Site Plan Review Committee (SPRC) September 26, 2024

Crystal House 7 and 8 – 1900 S. Eads St.

Site Plan Amendment (SPLA24-00012)

CH 7 and 8 Approved vs. Proposed

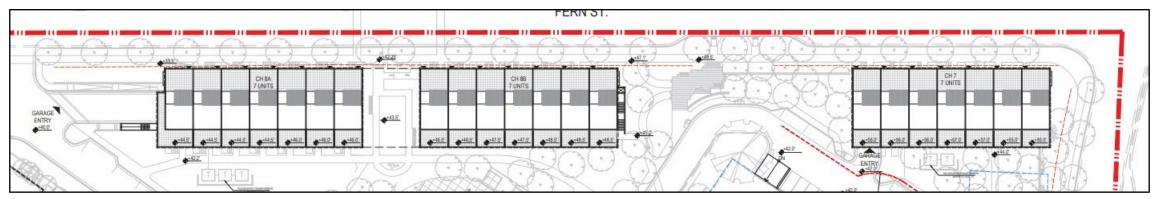
- CH 7 units: 7
- CH 8 units: 14
- CH 7 height: 34.68 feet
- CH 8 height: 26.18 feet
- 94 parking spaces
 - CH 7 parking spaces: 28 (2 compact)
 - CH 8 parking spaces: 66 (1 compact)
 - Parking ratio for site= 0.65
- 22 bike parking spaces
- 2 story multi-family buildings that face
 South Fern Street with rear decks/patios
- Roof terrace with pergola
- Residential gross floor area: 45,367 sq ft
- 2 accessible units

- CH 7 units: 14 (+7 units)
- CH8 units: 28 (+14 units)
- CH 7 height: 46.67 feet (increase of 11.99 feet)
- CH 8 height: 38.17 feet (increase of 11.99 feet)
- 84 parking spaces
 - CH 7 parking spaces: 28 (14 compact)
 - CH 8 parking spaces: 56 (28 compact)
 - Parking ratio for site = 0.6
- 24 bike parking spaces (increase of 2 spaces)
- 3 story multi-family buildings with basement (garage), back to back with front doors facing South Fern Street (west) or internal courtyards (east)
- Roof terrace and loft (without pergola)
- Residential gross floor area: 88,018 sq ft (increase of 42,651 sq ft)
- 1,273 square feet of density exclusions for ancillary spaces in the underground parking garage that will be utilized for tenant storage
- Reduce and relocate number of transformers
- 0 accessible units

Site Plan

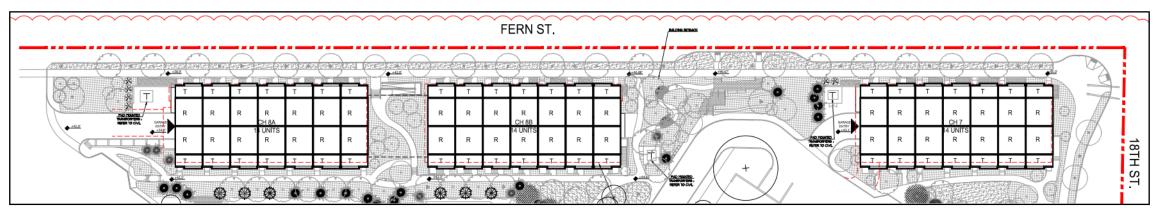
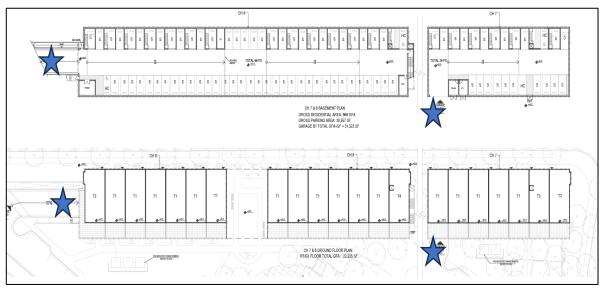
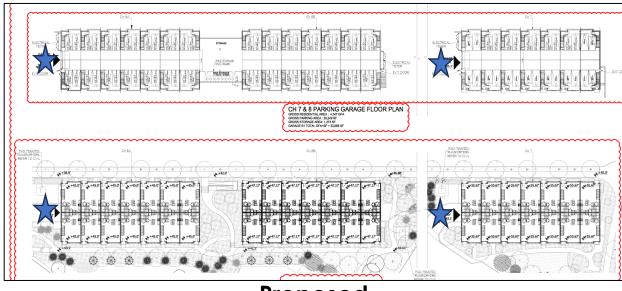
- Revise parking garage layout
- Reduce the parking ratio (compact parking ratio modification)
- Revise courtyard layout
- Modify location of transformers

Garage and Ground Floor Plans

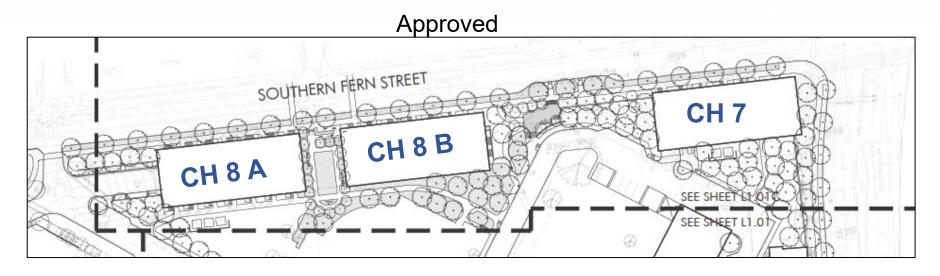
94 parking spaces for 21 units, site ratio= 0.65

CH 7 parking spaces: 28 (2 compact)

CH 8 parking spaces: 66 (1 compact)

4 accessible spaces

22 bike parking spaces

21 in private garage 1 at Fern Street

84 parking spaces for 42 units, site ratio= 0.60

CH 7 parking spaces: 28 (14 compact)

CH 8 parking spaces: 56 (28 compact)

0 accessible spaces

24 bike parking spaces 22 in private garage 2 at Fern Street

Crystal Houses Site Plan Amendment

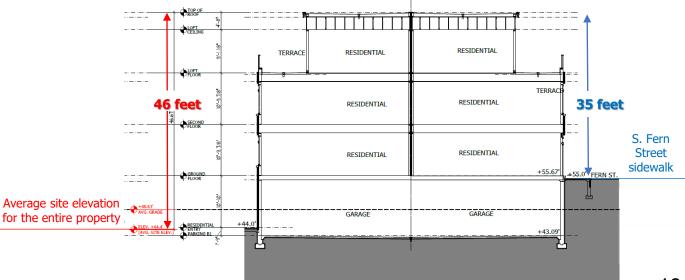
- The proposal, otherwise meeting the vision for the built environment along S.
 Fern Street, technically measures 46 feet in height due to the overall Crystal Houses average site elevation
- The garage/basement level shown here has demonstrated that less than half of its height is above the adjoining grade and therefore does <u>not</u> represent a story

Proposed ACZO Amendment

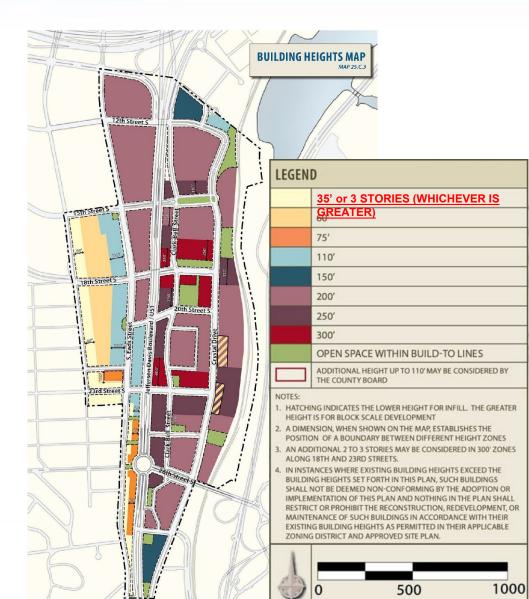
- Since factors potentially limiting the delivery of the envisioned 3-story form of development exist in a specific location, the proposed amendment only targets the western edge of the Crystal City district, an area which is also envisioned to deliver primarily residential form of development
- Staff recommends expanding the legend title to permit the greater of either 35 feet or 3 stories in height
